Service Bulletin

Starair Aircraft Co., Ltd.

Document No.: 2023-SA60L-52-01

Subject	Replacement of components of the inner handle of the canopy lock
Category	Important
Applicability	This bulletin applies to the Aurora SA60L series and Aurora SA70L series light sport aircraft listed in Attached Table 1.
Finish Time	Aircraft within the scope of application must be done the work required by this service bulletin completely before July 31, 2024.
Reason	<p>The anti loosening method used for the canopy lock of Aurora SA60L series and Aurora SA70L series aircraft is based on the principle of mechanical linkage over dead center and the method of magnet adsorption. According to feedback from the user, due to vibration or arm contact during flight, the canopy lock may become partially released (the handle lock pin does not come out of the lock hole). To avoid the situation mentioned above, Aircraft within the scope of application are required to replace the handle components of the canopy lock according to the required actions of this bulletin (at their own expense) .</p> <p>Issue Date: October 27, 2023 Effective Date: October 27, 2023</p>

B. The schematic diagrams before and after replacing the inner handle of the canopy lock are as follows.

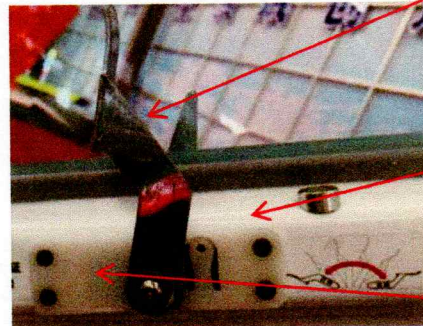
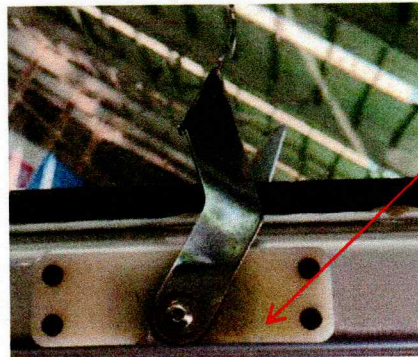
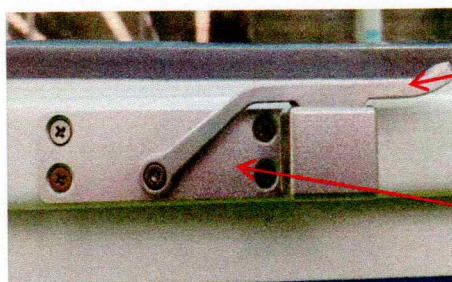
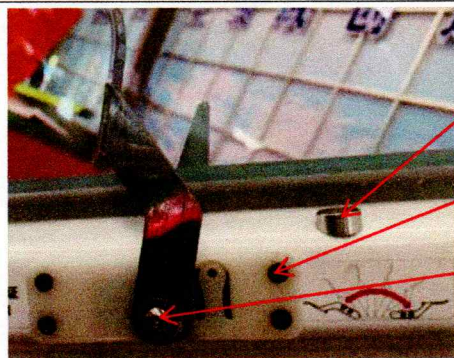
Before replacing

After replacing

A. Follow the steps below to replace the inner handle of the canopy lock.

2. Sub assembly of the buckle lock for Left/Right Inner Handle plate. (Complete this step before leaving Starair Aircraft Co.,Ltd.)

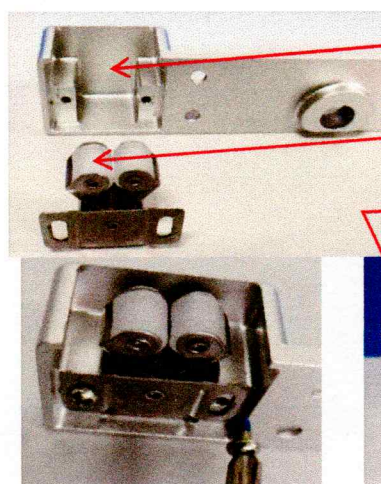
a、 As shown in the following figures, place the protruding side of the buckle lock inward into the slot of the inner handle plate, screw in (701309004029 screw M4X8-ZnD GB/T 818), adjust the buckle lock so that the bottom surface of the buckle lock is tightly attached to the bottom surface of slot of the inner handle plate.

b、 After adjustment, remove (701309004029 screw M4X8-ZnD GB/T 818), apply Loctite 243, and tighten it with a cross screwdriver.

c、 Assemble the inner handle on the other side in the same way as above.

3. Installation of buckle of the left/right inner handle. (Complete this step before leaving Starair Aircraft Co.,Ltd.)

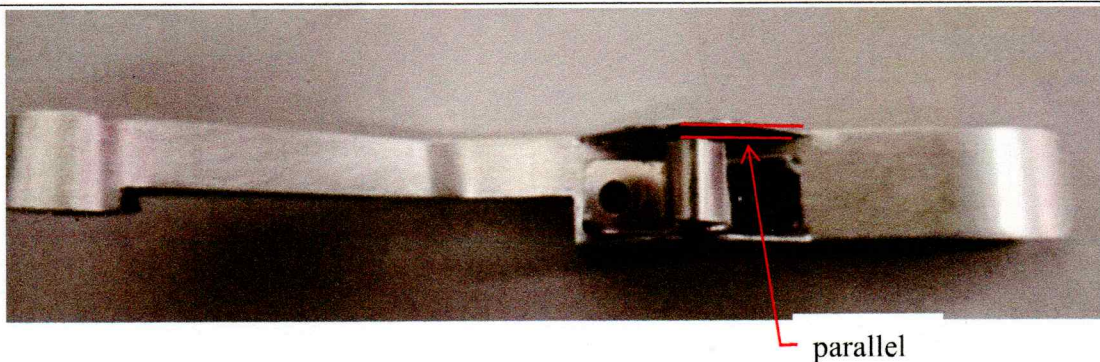
a、 As shown in the following figures, align the buckle with the installation hole of the inner handle, screw in (701309004003 screw M4X6-A2-70 GB/T 818), adjust the buckle so that the side of the buckle is parallel to the side of the inner handle.

b、 After adjustment, remove (701309004003 screw M4X6-A2-70 GB/T 818), apply Loctite 243, and tighten it with a cross screwdriver.

c、 Install the inner handle on the other side in the same way as above.

4. Installation of left/right inner handle plate.

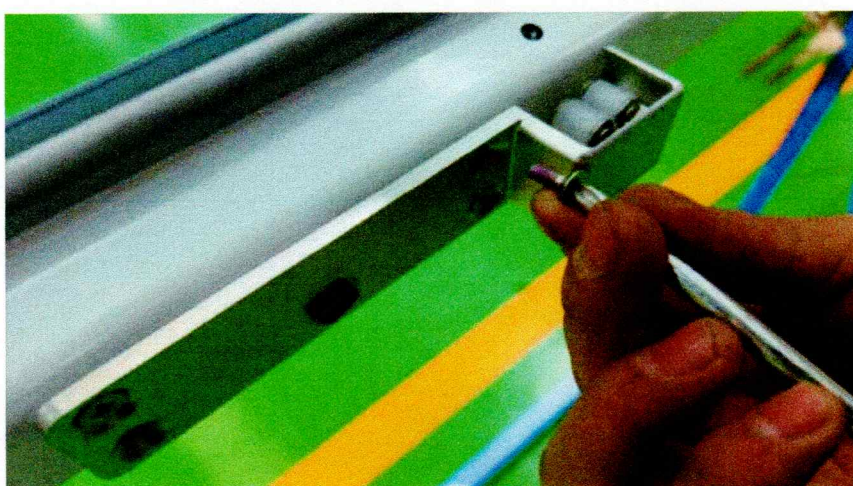
As shown in the following figure, insert the camshaft into the hole of the inner handle plate, align the installation hole of the inner handle with the fixing hole of the canopy, and screw (701312004210 countersunk head tapping screw ST4.2X13 GB/T 846) into the installation hole of the inner handle plate. If the thread inside the canopy frame slides during disassembly, use a hand electrical drill to enlarge the diameter of the countersunk holes of (3168000019 left inner handle plate) and (3168000018 right inner handle plate) to D5, and then screw (7110000805 countersunk head tapping screw ST4.8X12 GB/T846) into the installation hole of the inner handle plate. Tighten it with a cross screwdriver.
